SUBJECT: COMANCHE PEAK NUCLEAR POWER PLANT, UNITS 1 AND 2 - STAFF ASSESSMENT OF INFORMATION PROVIDED PURSUANT TO TITLE 10 OF THE *CODE OF FEDERAL REGULATIONS* PART 50, SECTION 50.54(f), SEISMIC HAZARD REEVALUATIONS FOR RECOMMENDATION 2.1 OF THE NEAR-TERM TASK FORCE REVIEW OF INSIGHTS FROM THE FUKUSHIMA DAI-ICHI ACCIDENT AND STAFF CLOSURE OF ACTIVITIES ASSOCIATED WITH RECOMMENDATION 2.1, "SEISMIC" (CAC NOS. MF3937 AND MF3938)

STAFF ASSESSMENT BY THE OFFICE OF NUCLEAR REACTOR REGULATION

RELATED TO SEISMIC HAZARD AND SCREENING REPORT

COMANCHE PEAK NUCLEAR POWER PLANT, UNITS 1 AND 2

Figure 3.3-1 Plot of Staff's and Licensee's Base Case Shear-Wave Velocity Profiles for the CPNPP site

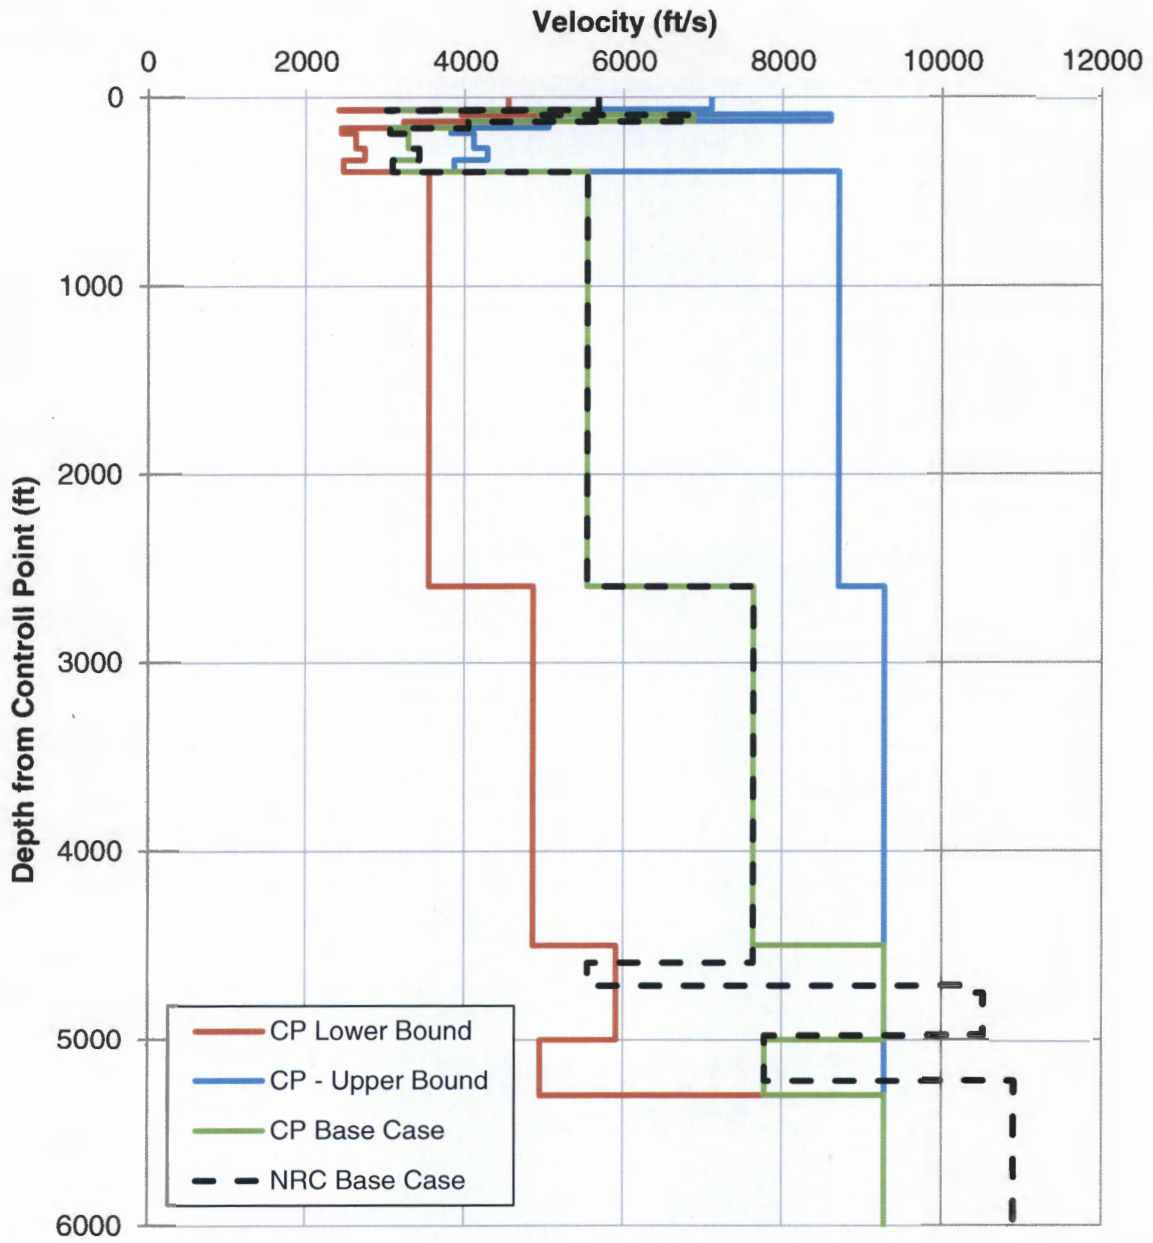
response calculations, the NRC staff employed the RVT approach and developed input ground motions in accordance with Appendix B of the SPID. Similar to the licensee's approach, the NRC staff's shear wave velocity profile is adapted directly from the CPNPP, Units 3 and 4 COL FSAR as the operating plant is close to the COL site, and the site geology is uniform. Since the licensee also used the same measurements, the two base case velocity profiles are almost identical. Unlike the licensee, however, the NRC staff used a single base case velocity profile, because there is sufficient data to construct a reliable shear wave velocity profile. To capture the uncertainty in the depth to base rock beneath the site, the staff used a natural log sigma of 0.1 resulting in a basement uncertainty of about ± 650 feet (200 m). Figure 3.3-1 of this assessment shows a comparison of the licensee's and NRC staff's shear wave velocity profiles for the CPNPP site, which for the middle base case profile are very similar. The only differences are observed at a depth below 4500 ft (1370 m). While the NRC staff's velocity model follows the profile used for the CPNPP, Units 3 and 4 COL, the licensee's model has a smoother velocity gradient. Because these varying velocity layers are at a significant depth and relatively thin, this minor difference does not result in any significant impact in the site response calculations.

Figure 3.3-2 Plot Comparing the Staff's and the License's Median Amplification Functions and Uncertainties for the CPNPP site

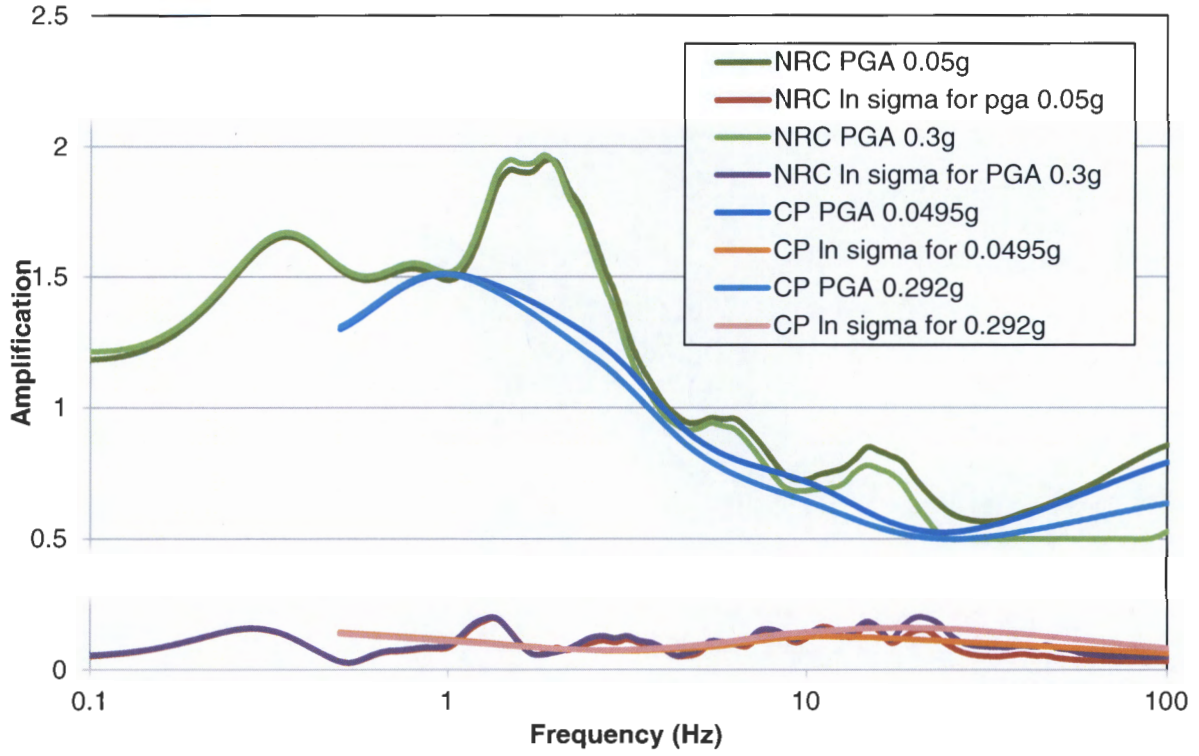
Figure 3.3-2 of this assessment shows a comparison of the NRC staff's and licensee's median site amplification functions and uncertainties (± 1 standard deviation) for 2 of the 11 input loading levels. As shown in Figure 3.3-2, the NRC staff's and licensee's amplification factors follow a similar trend; however, the staff's amplification factors are somewhat larger between 1 to 5 Hz. Figure 3.3-3 of this assessment shows a comparison of the staff's and licensee's control point hazard curves for 1 Hz, 10 Hz and PGA. As shown in Figure 3.3-3, the licensee's control point hazard curves are slightly higher than the NRC staff's curves for these three frequencies. Appendix B of the SPID provides guidance for performing site response analyses, including capturing the uncertainty for sites with less subsurface data; however, the guidance is neither entirely prescriptive nor comprehensive. As such, various approaches in performing site response analyses, including the modeling of uncertainty, are acceptable for the 50.54(f) response.

Figure 3.3-3 Plot Comparing the Staff's and the Licensee's Mean Control Point Hazard Curves at a Variety of Frequencies for the CPNPP site

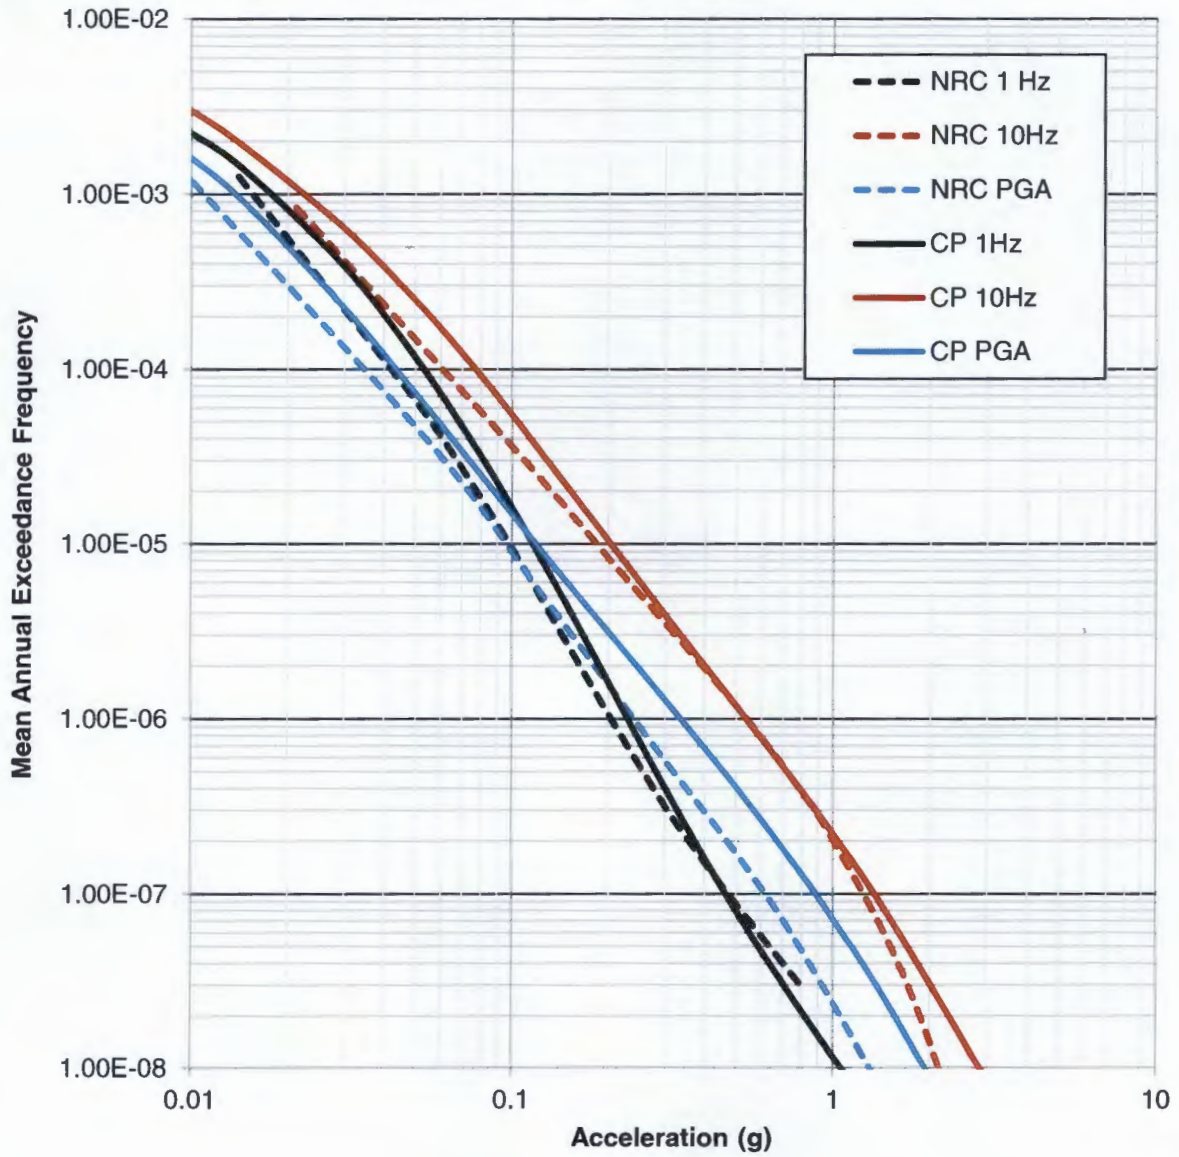
In summary, the NRC staff concludes that the licensee's site response was conducted using present-day guidance and methodology, including the NRC-endorsed SPID. The NRC staff performed independent calculations, which confirmed that the licensee's amplification factors and control point hazard curves adequately characterize the site response, including the uncertainty associated with the subsurface material properties, for the CPNPP site.

Figure 3.4-1 Comparison of the Staff's GMRS with Licensee's GMRS and the SSE for the CPNPP site

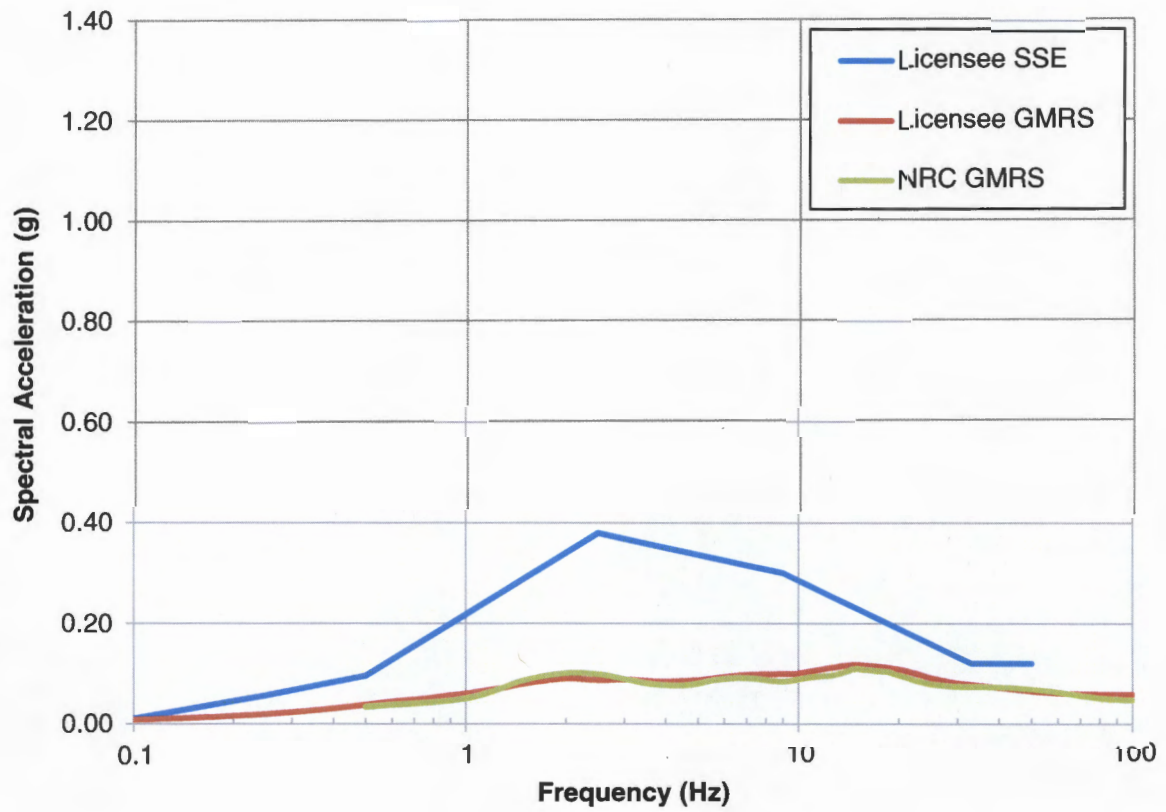
The NRC staff independently calculated the 10^{-4} and 10^{-5} UHRS using the results of its confirmatory PSHA and site response analyses, as described in Sections 3.2 and 3.3 of this staff assessment, respectively. Figure 3.4-1 of this assessment shows a comparison of the GMRS determined by the licensee to that determined by the NRC staff. As shown in Figure 3.4-1, the licensee's GMRS is very similar to the staff's confirmatory GMRS.
